**CHANGE ORDER**  
**CITY OF VALDEZ**

**DATE ISSUED:** April 21, 2016  
**CHANGE ORDER NO.** 29  
**COST CODE NO.** 310-9507-58000  
**PROJECT NO.** 11-310-9507  
**CONTRACT NO.** 1091

**PROJECT:** Valdez Middle School

Valdez Middle School  
Dawson Change Order 29 Breakdown

**C203**  
EAST SITE PLAN

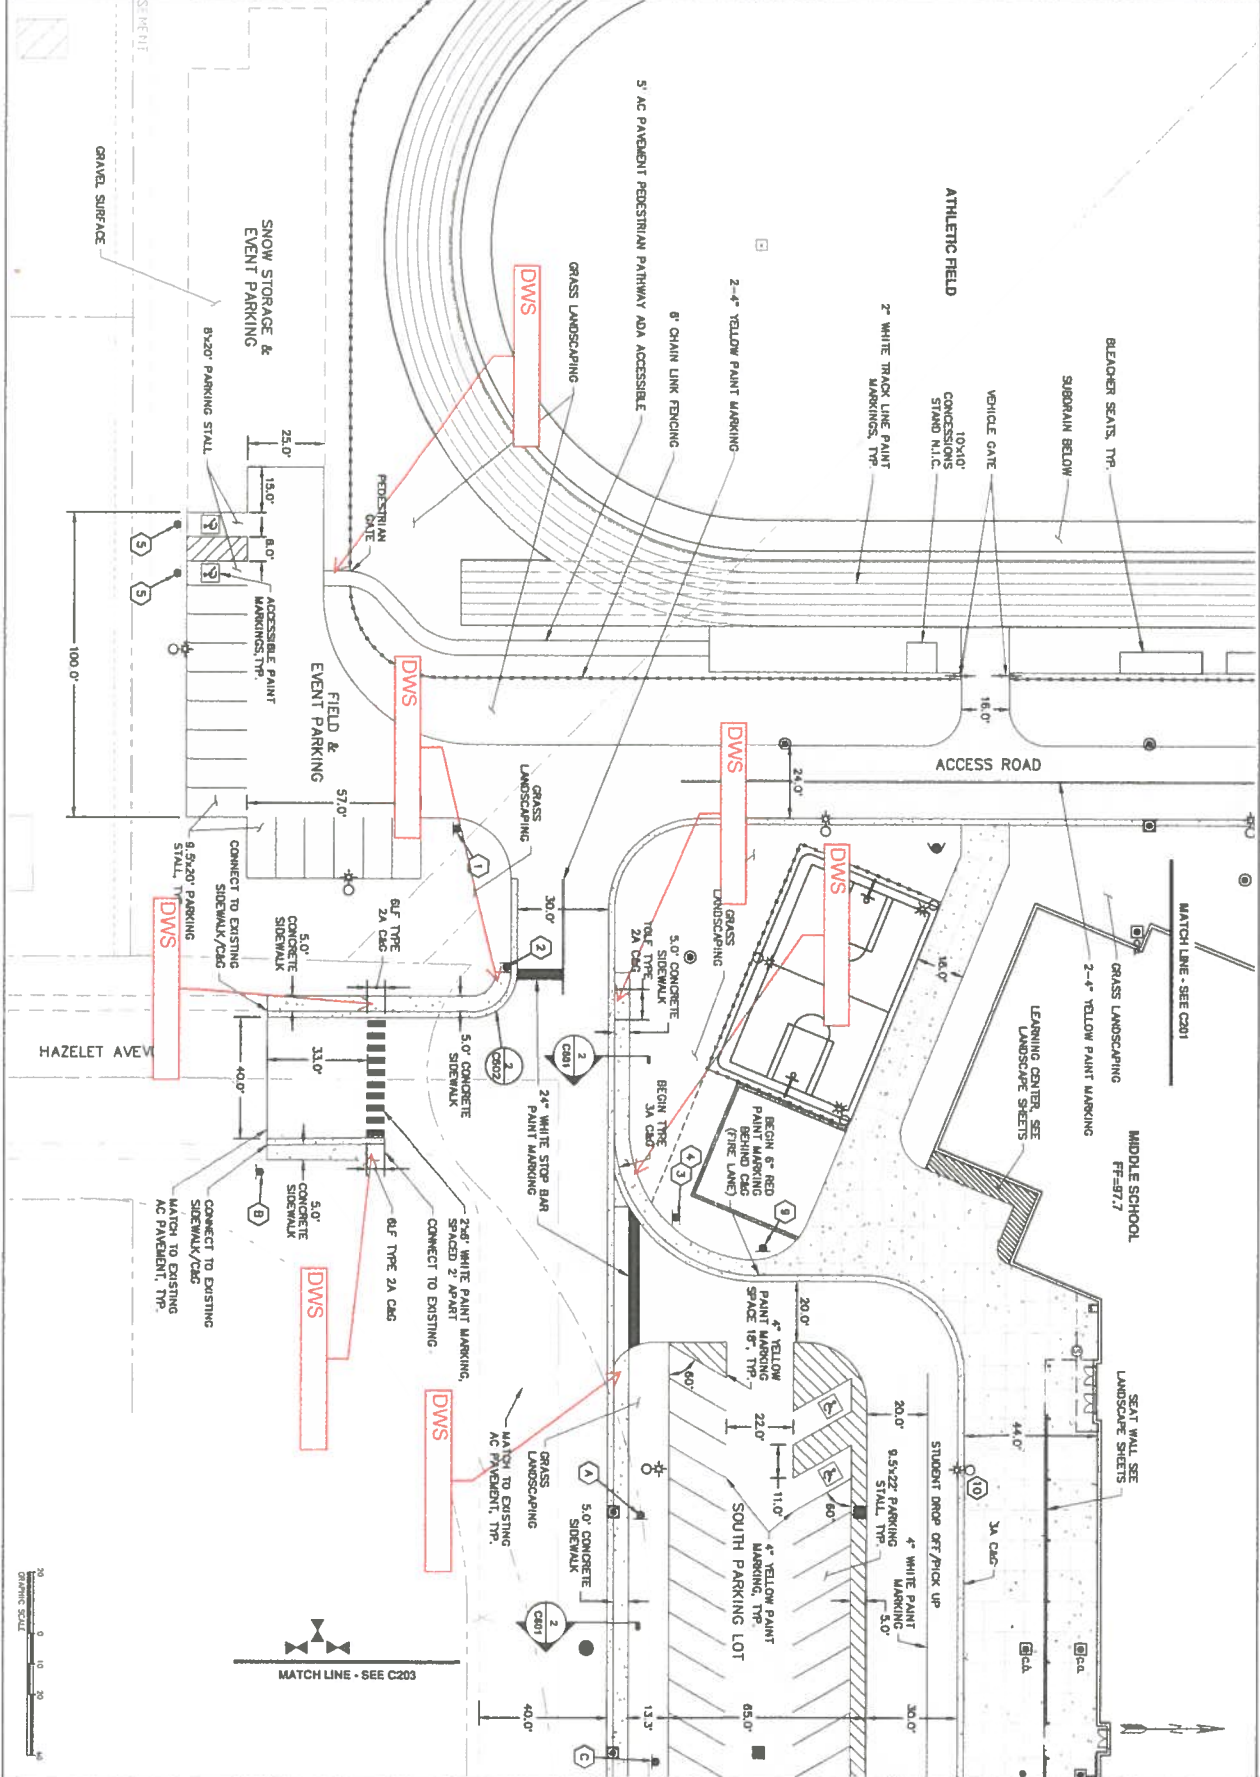
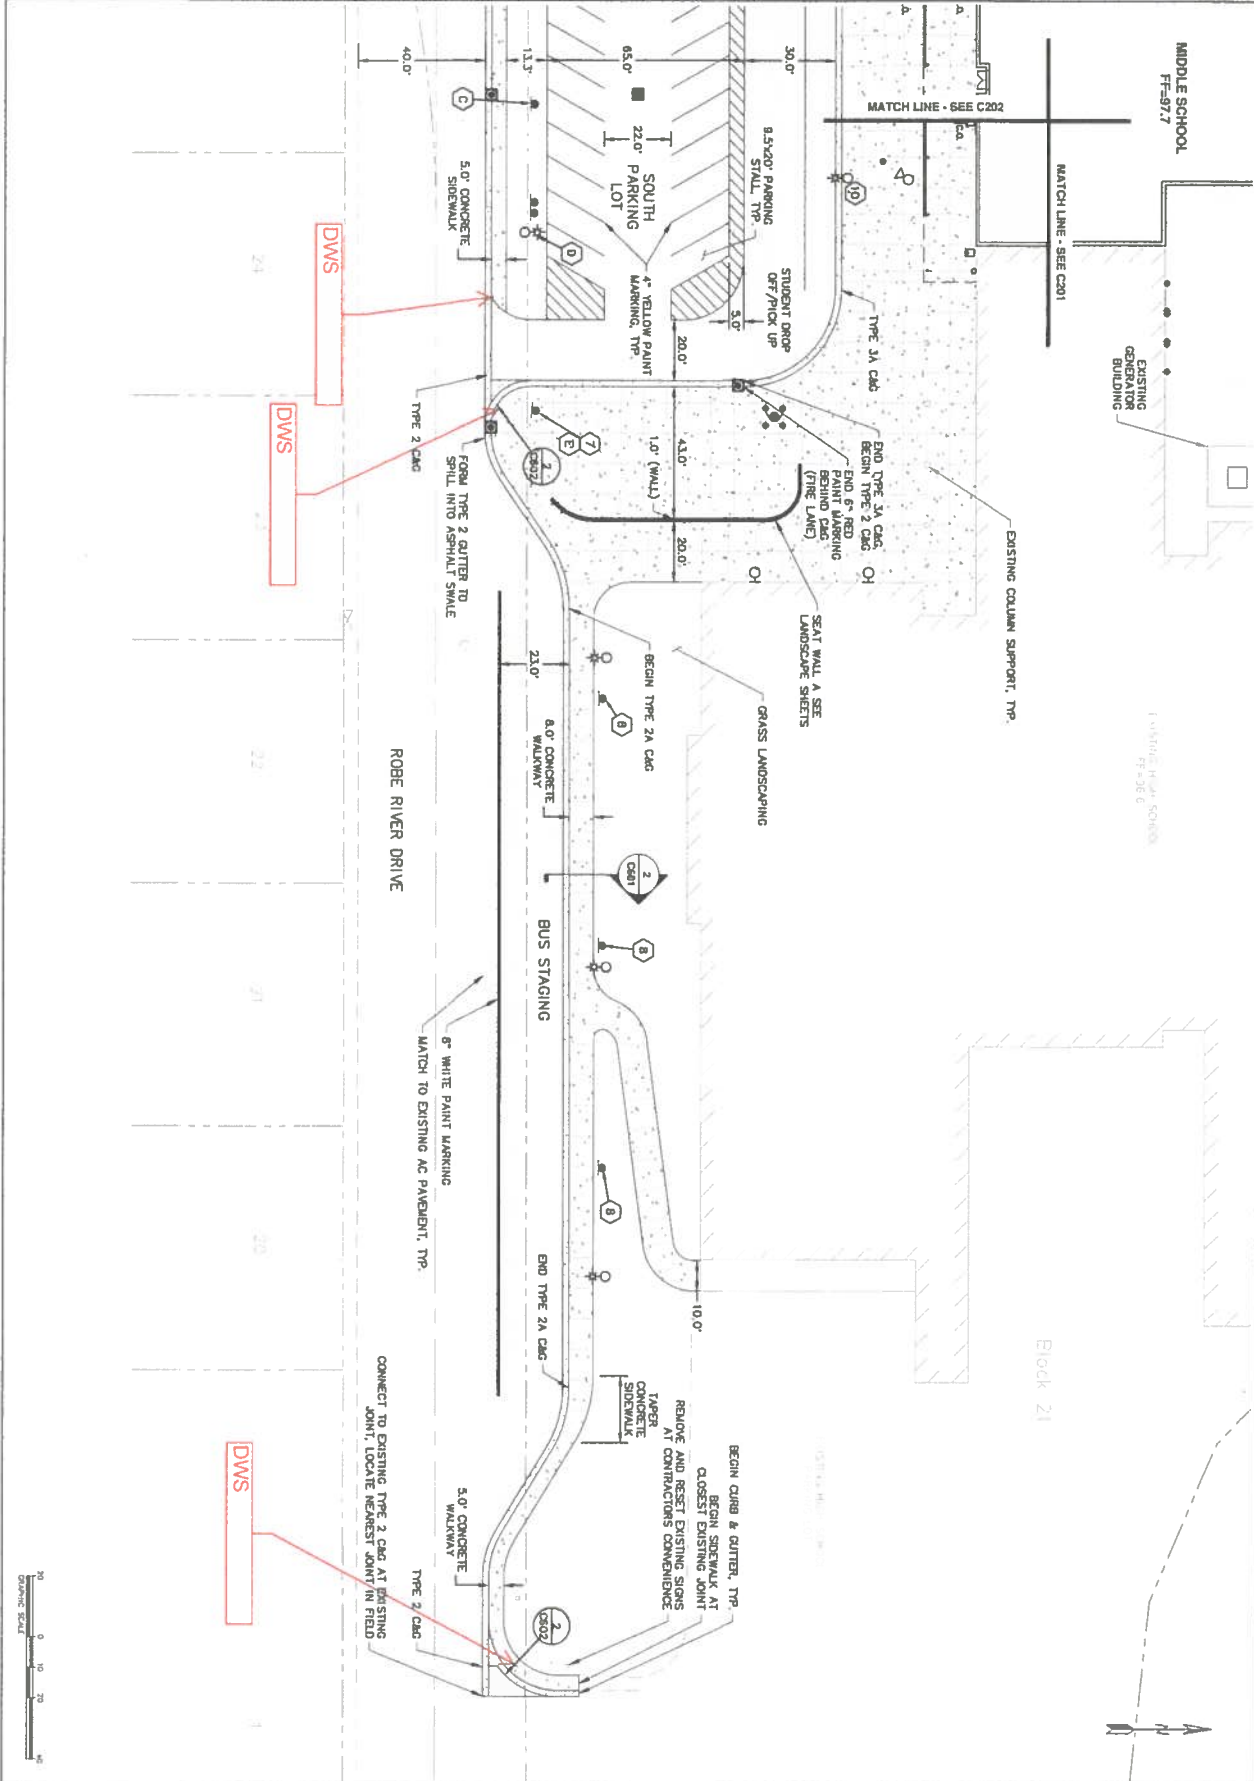
There are 3 conditions for detectable warning tile surfaces shown on C602, perpendicular curb ramp, curb ramp at driveway, and parallel curb ramp. Some of these locations are identified on the Civil Site Plans C201-C203 by calling out the associated detail. There are locations which are unclear as to whether or not these warning tiles should be installed, see the attached markups as an example. We would like to verify these locations so as not to install too many or too few. Please review the entire site or areas of work and provide clear direction for each location and size of tiles with the relevant details from C602.

See attached drawing C202 and C203 showing locations where to install detectable warning surfaces.

**ASI-091**

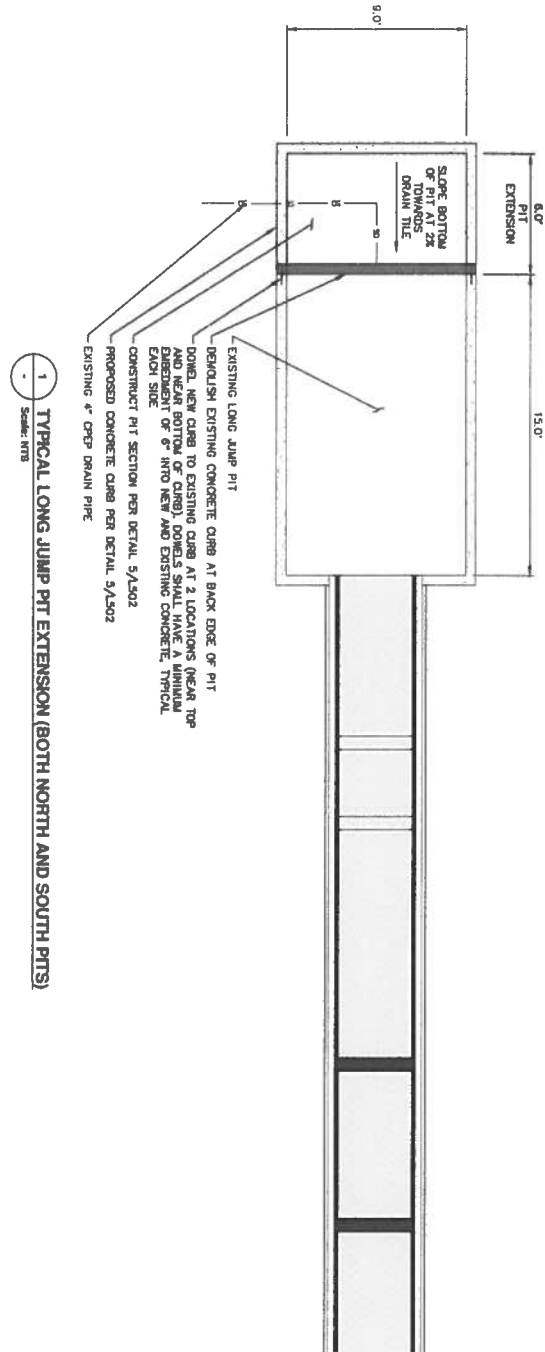
**Scope Description:** Demolish existing concrete curb at back edge of both 15-foot long pits; install dowels to existing curbs at both sides; construct new 6-foot long concrete extension (21' total length) at both pits.

<b>ARCHITECTURAL SUPPLEMENTAL INFORMATION</b>		ASI TOPIC <b>Extend Long Jump Pit</b>		ORIGINATOR <b>CRW</b>		SUBMITTED ON <b>06/16/2014</b>		ASI NO. <b>091</b>	
<b>SECTION I - GENERAL/REFERENCE</b>									
WRITTEN BY: Mike Leguineche				CONTRACT DWG:		SPEC:			
COST IMPACT:		<b>YES <input checked="" type="checkbox"/></b>		<b>NO <input type="checkbox"/></b>		<b>UNKNOWN</b>		SHOP DWG:	
								OTHER:	
<b>SECTION II - ARCHITECTURAL SUPPLEMENTAL INFORMATION</b>									
<p>Extend long jump pits per owner request. See attached SKC-029.</p> <p>Provide rounded edge at interior edge of pit extension. Ease interior edges at existing pit wall with sharp corners.</p>									
<b>SECTION III - OWNER REMARKS</b>									
<p>APPROVED <input type="checkbox"/> DISAPPROVED <input type="checkbox"/> INITIATE RFP? <input type="checkbox"/> IWA/RFP# <input type="text"/></p>									
SIGNATURE:				Arcadis			DATE:		
<b>SECTION IV - CONTRACTOR RESPONSE</b>

**ASI-092**

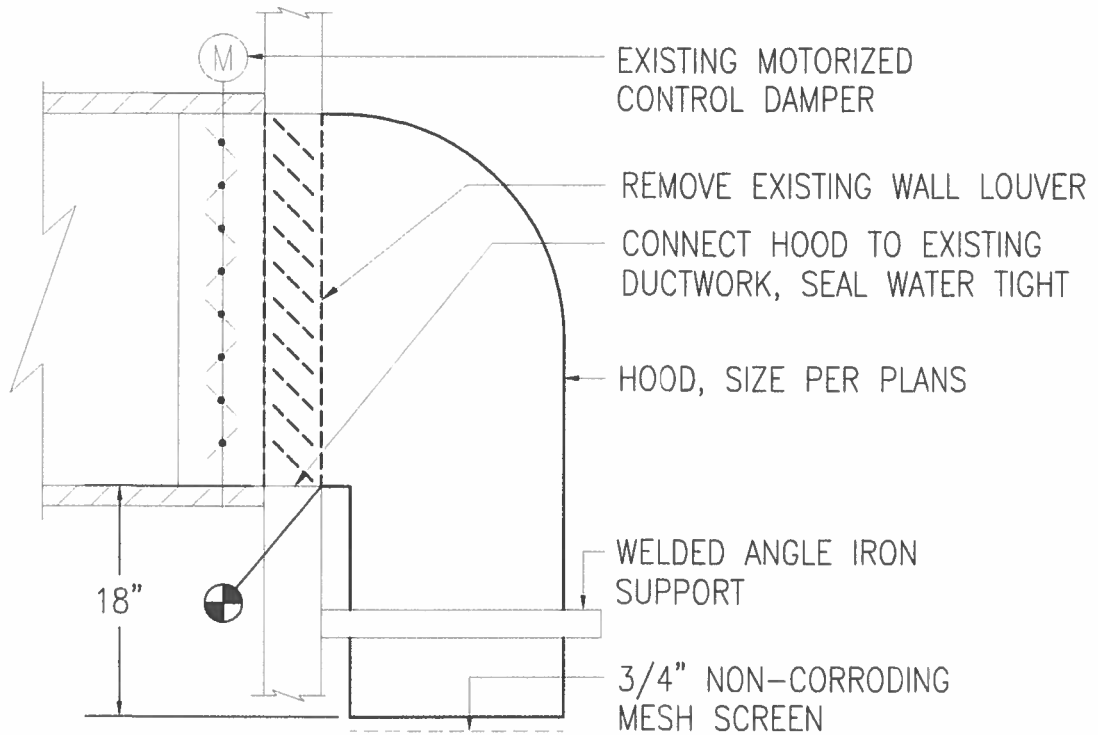
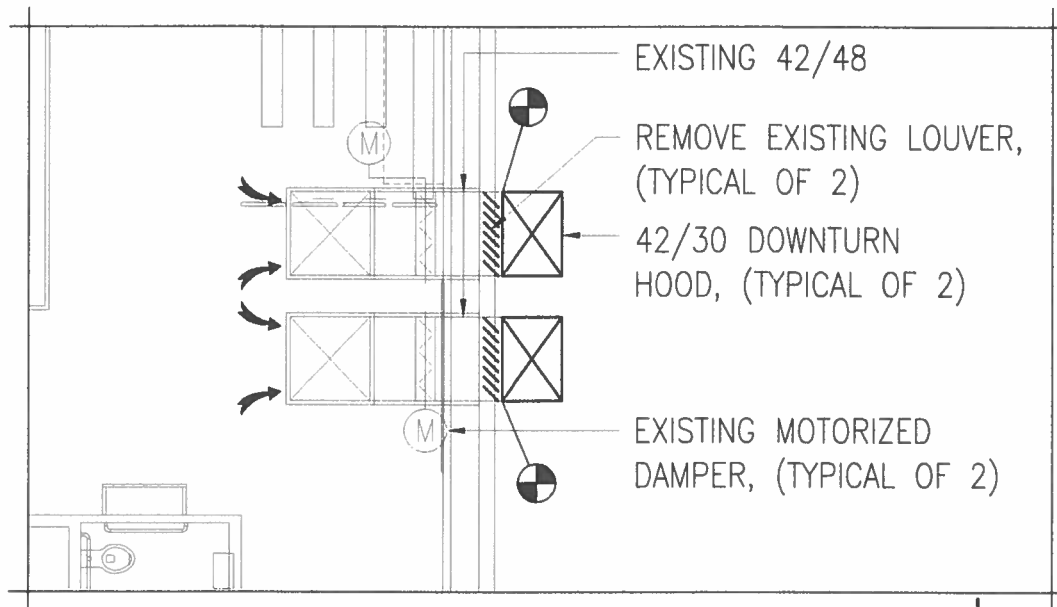
**Scope Description:** Remove existing wall louver that provide relief air for the gym; furnish and install new galvanized hoods and supports; connect hoods to existing ductwork and provide watertight seal.

<b>ARCHITECTURAL SUPPLEMENTAL INFORMATION</b>		ASI TOPIC <b>Gym Relief Hoods</b>		ORIGINATOR <b>RSA</b>		SUBMITTED ON <b>7/08/15</b>		ASI NO. <b>092</b>	
<b>SECTION I - GENERAL/REFERENCE</b>									
WRITTEN BY: Chris Rude				CONTRACT DWG: M102 and M403		SPEC: 23 33 00			
COST IMPACT:		<b>YES</b> <input checked="" type="checkbox"/>		<b>NO</b> <input type="checkbox"/>		<b>UNKNOWN</b> <input type="checkbox"/>		SHOP DWG:	
						OTHER:			
<b>SECTION II - ARCHITECTURAL SUPPLEMENTAL INFORMATION</b>									
<p>The owner has requested that the gym relief louvers be replaced with relief hoods to add protection from the elements entering the gym. See attached sketch, SKM-26.</p> <p>Attach hood with 4 #10 screws each side run from inside each hood into the jambs, header and sill of the framed openings.</p> <p>Relief hood assemblies shall be galvanized.</p>									
<b>SECTION III - OWNER REMARKS</b>

**ATHLETIC LOCKER BASE**

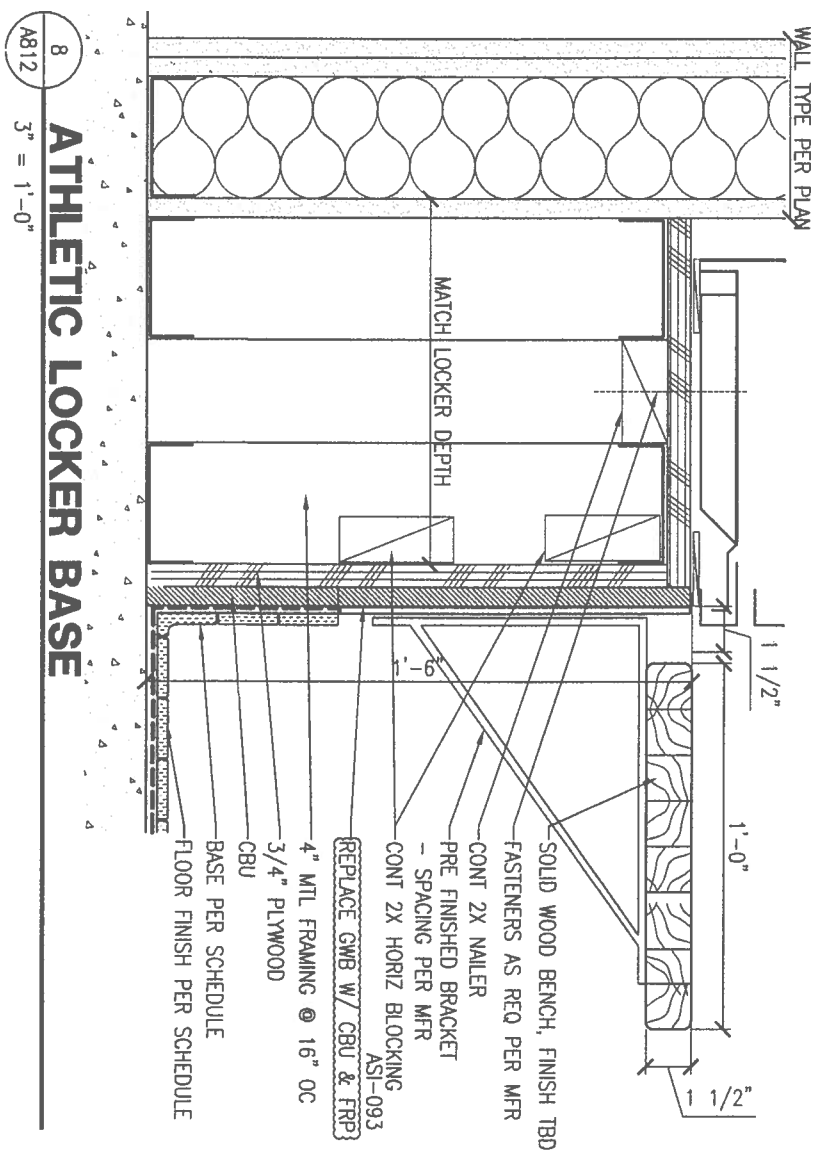
**Scope Description:** Remove existing painted gypsum board on walls below athletic lockers in Locker Rooms 112 and 113. Replace with 1/2" cement board "Durock" and fiber reinforced plastic (FRP) with PVC trim and sealant at perimeter and joints.

<b>ARCHITECTURAL SUPPLEMENTAL INFORMATION</b>		ASI TOPIC <b>Athletic Locker Base</b>		ORIGINATOR <b>BNAP</b>		SUBMITTED ON <b>7/31/15</b>		ASI NO. <b>093</b>	
<b>SECTION I - GENERAL/REFERENCE</b>									
WRITTEN BY: Jon Denton				CONTRACT DWG: 8/A812		SPEC:			
COST IMPACT:		YES <input checked="" type="checkbox"/>		NO <input type="checkbox"/>		UNKNOWN <input type="checkbox"/>		SHOP DWG:	
						OTHER:			
<b>SECTION II - ARCHITECTURAL SUPPLEMENTAL INFORMATION</b>									
Remove gypsum board located below athletic lockers in Locker Rooms 112 and 113 and replace with CBU and FRP. FRP finish shall be smooth white. Install with white PVC trim at perimeter and at joints. See attached SKETCH ASI-093									
<b>SECTION III - OWNER REMARKS</b>									
APPROVED <input type="checkbox"/>		DISAPPROVED <input type="checkbox"/>		INITIATE RFP?		IWA/RFP#			
SIGNATURE:				Arcadis		DATE:			
<b>SECTION IV - CONTRACTOR RESPONSE</b>
